Subject: CZ-19-0673-42 – Design Build Construction of Heating, Ventilation, and Air Conditioning (HVAC) at Multiple Sites – Package A (SDUSD Project # 92550071.1)

Notice to Proceed: No. 17– Paint Rooftop Duct at Sessions Elementary School

Project: SDUSD HVAC Design Build Projects **Contingency Adjustment Proposal No:** Sessions ES 06r2

Contract No: CZ-19-0673-42 **Subject:** Paint Rooftop Duct, stands and RTU trim per SDUSD provided plan and direction.

Picture taken by Neighbor of school, towards Library rooftop ductwork (See 2 pages)

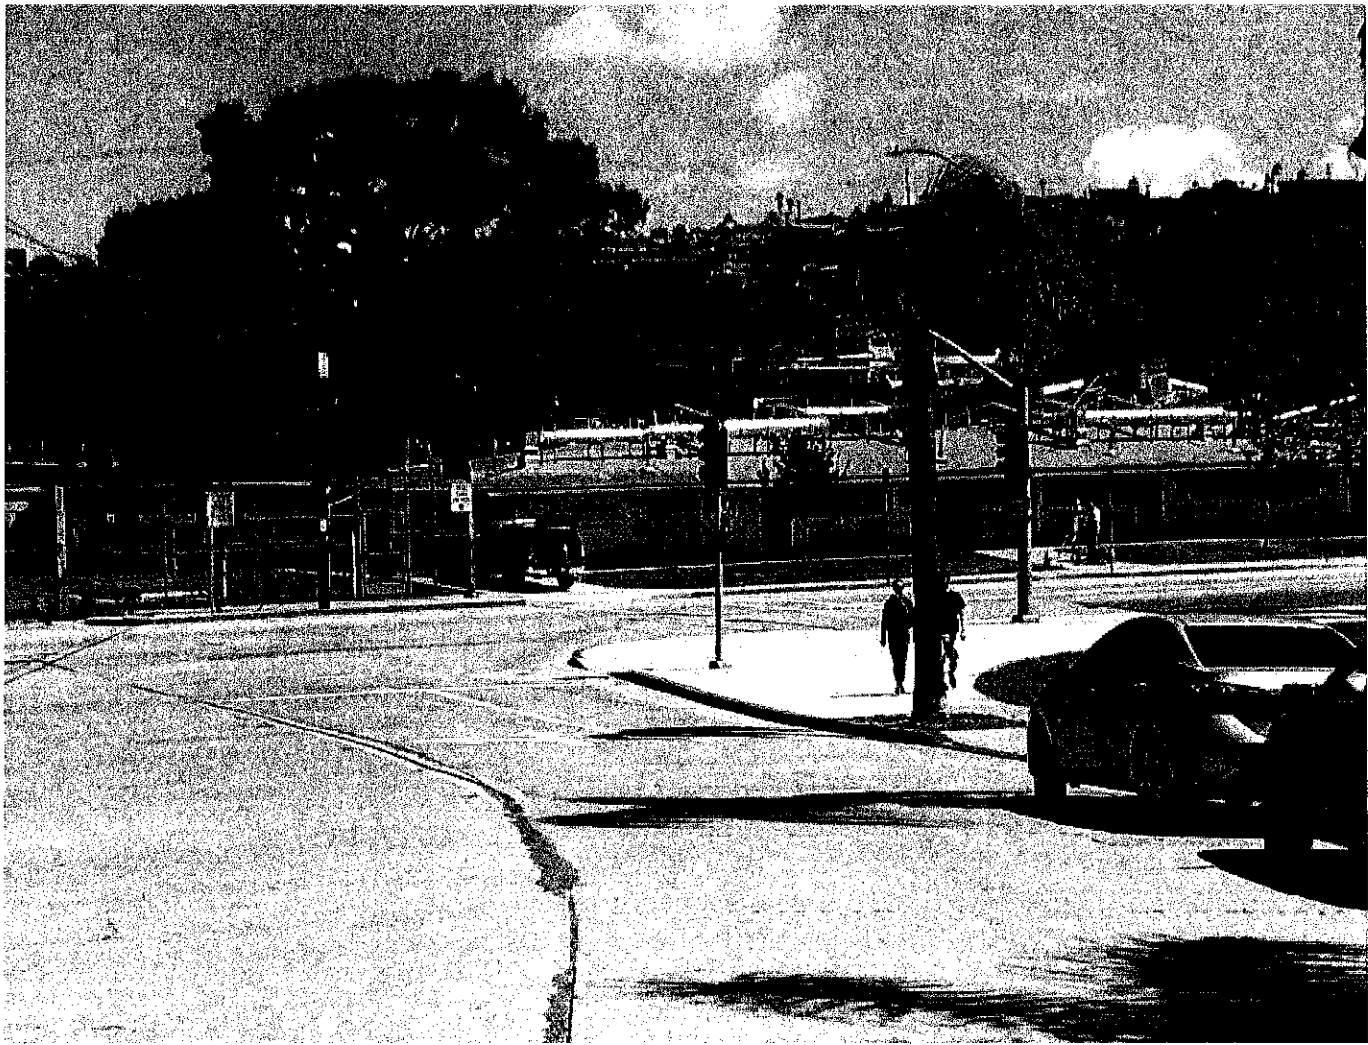
Comments : SDUSD requested a site visit to address complaints from neighbors regarding duct system glare. We did a site visit and we found that in some sections of duct system the glare is blinding and present, we recommend that the sections mentioned below be painted/masked to alleviate current complaints from neighbors.

Item #	Description	Comments	Consultant
Architectural			
Roof top ductwork	Architectural	<p>During site visit it was observed that a on certain areas of the rooftop ductwork, a paint or masking is recommended due to the following factors:</p> <ol style="list-style-type: none"> 1. Rooftop ductwork creates an intense glare that affects pedestrians and neighbors on Beryl Street. (See pictures on page 4-6) 2. Rooftop ductwork creates an intense glare that affects motorists driving west to east on Beryl street and vice versa. This is also present on Noyes street coming down the hill (See pictures on page 7 & 8). to prevent a possible distraction or blinding to the drivers on these roads, it is recommended that some paint or masking be applied to the ductwork in question. See pictures and marked 3. Rooftop ductwork creates an intense glare that affects neighbors behind the school. North and North west hillside homes (See pictures on page 2 and 3) <p>These recommendations are to be discussed and approved per Project Coordinator and CM's. Cost will have to be provided per GC.</p>	N/A
